MARK	DATE	DESCRIPTIONS	BY	CH'D
1	07/21/06	E2 CAP BEAM ISD, E2T1 CCO 34	AS	NV

SAN FRANCISCO OAKLAND BAY BRIDGE
EAST SPAN SEISMIC SAFETY PROJECT
SELF-ANCHORED SUSPENSION BRIDGE
(SUPERSTRUCTURE & TOWER)

PIER E2 DETAILS NO.2

⚠ CROSSBEAM ELEVATION
1:50

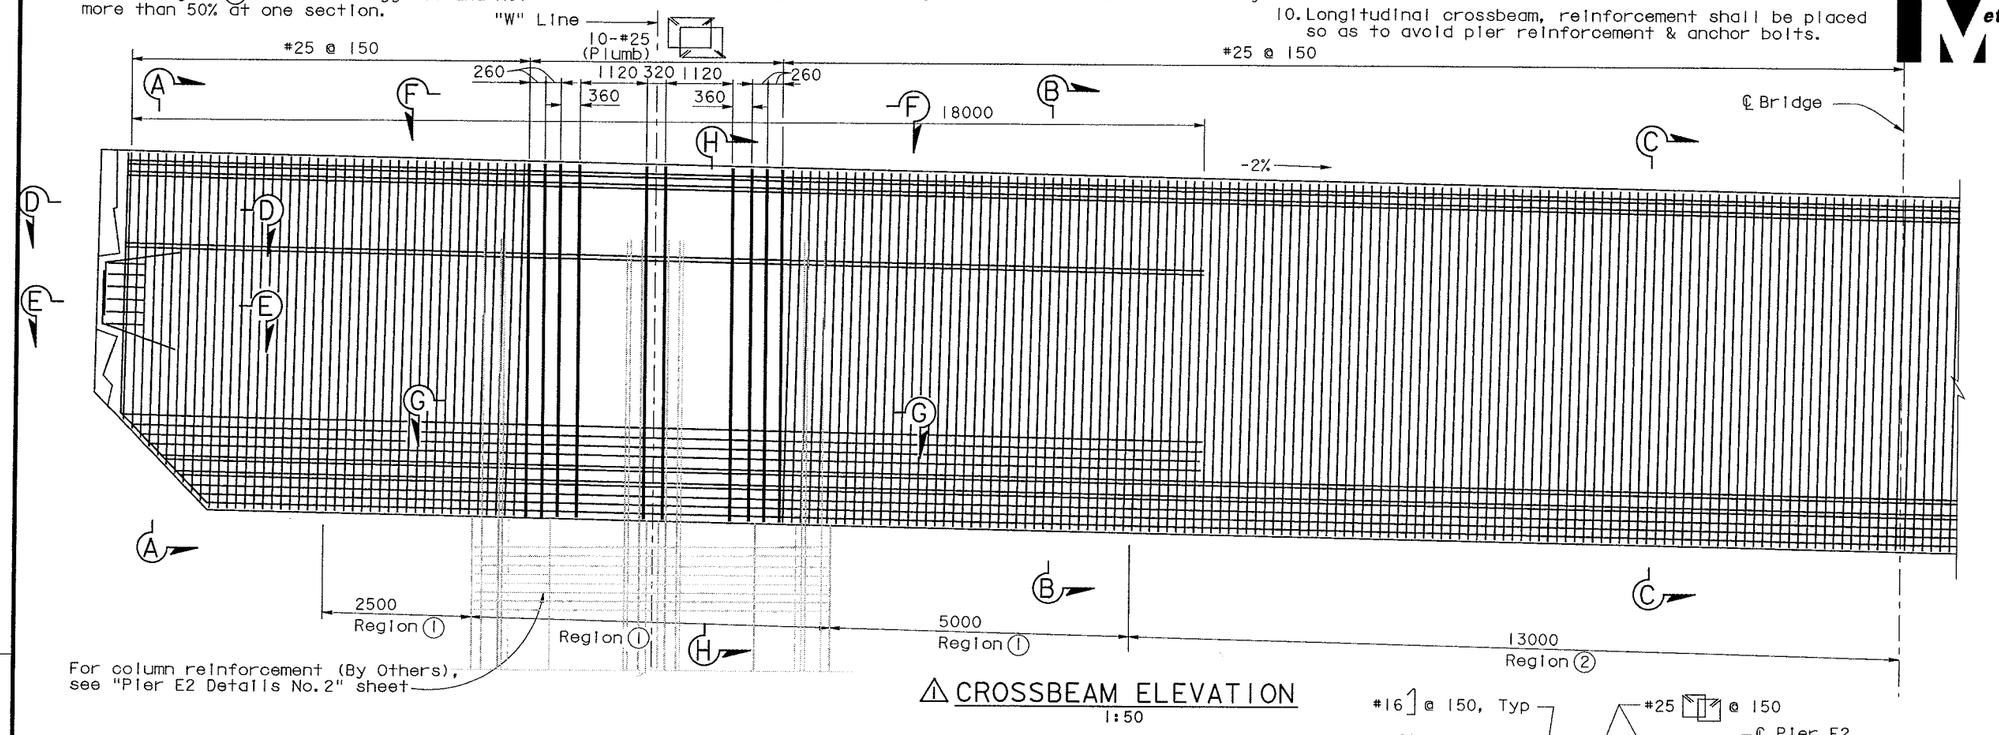
MARK	DATE	DESCRIPTIONS	BY	CH'D
1	07/21/06	E2 CAP BEAM ISD	AS	NV

⚠1 TOP TENDON PROFILE-PLAN

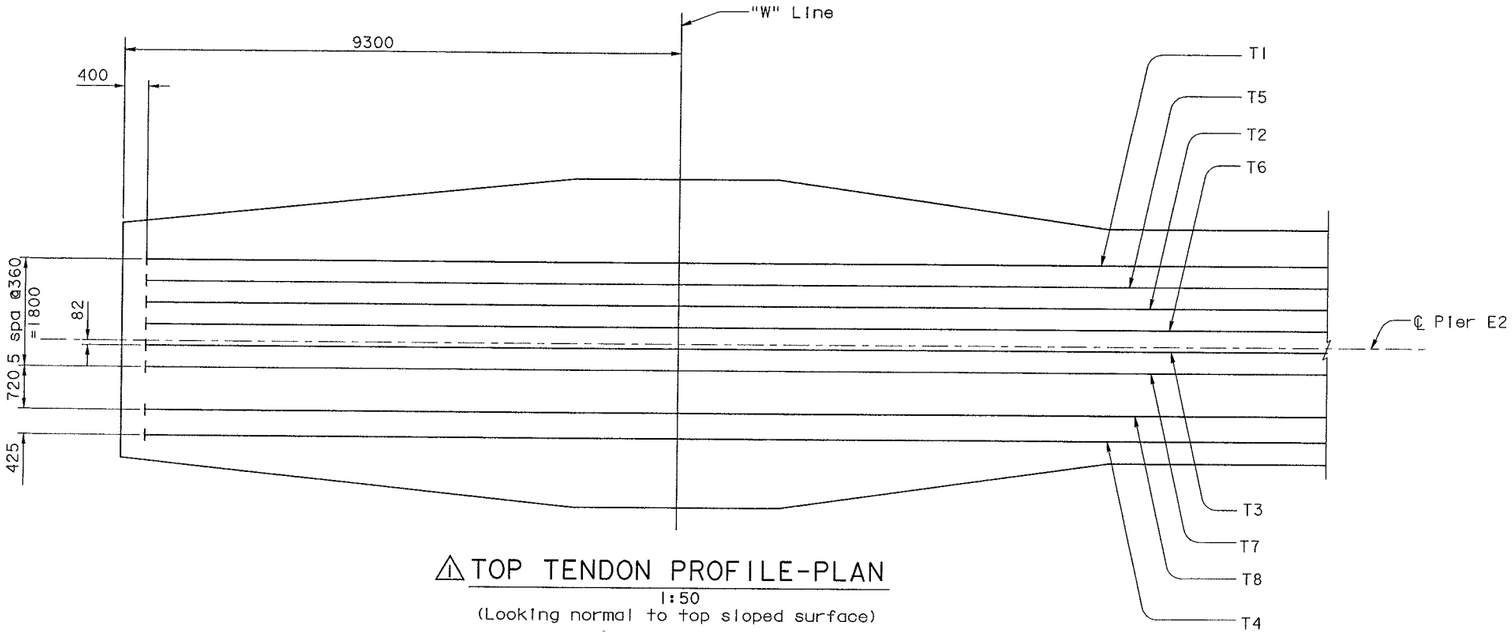
MARK	DATE	DESCRIPTIONS	BY	CH'D
⚠1	07/21/06	E2 CAP BEAM ISD	AS	NV

1. "W" Line shown, "E" Line similar.
2. For tendon anchorage block-out details, see "Pier E2 Details No.8" sheet.
3. For concrete crossbeam reinforcement, see "Pier E2 Details No.3", "Pier E2 Details No.4", and "Pier E2 Details No.7" sheets. ⚠1
4. For stressing force, use two end stressing and initial jacking stress $= 0.75\ f_{pu} = 0.75 \times 1860 = 1390$ MPa.
5. For additional prestressing notes, see Prestressing Notes" sheet.
6. The post-tensioning and grouting sequence shall prevent ducts from crushing.
7. ⚠1 The outer diameter of the PT duct shall not be greater than 180 mm.

⚠ TOP AND BOTTOM TENDON PROFILE-ELEVATION

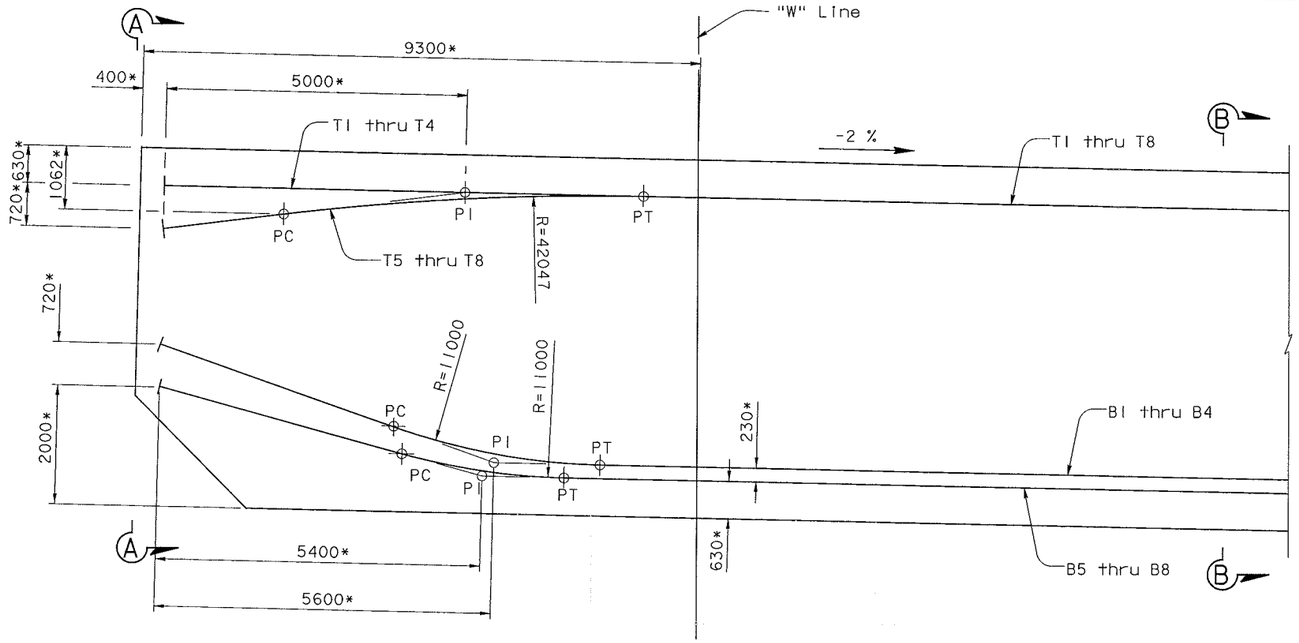
MARK	DATE	DESCRIPTIONS	BY	CH'D
1	07/21/06	E2 CAP BEAM ISD	AS	NV
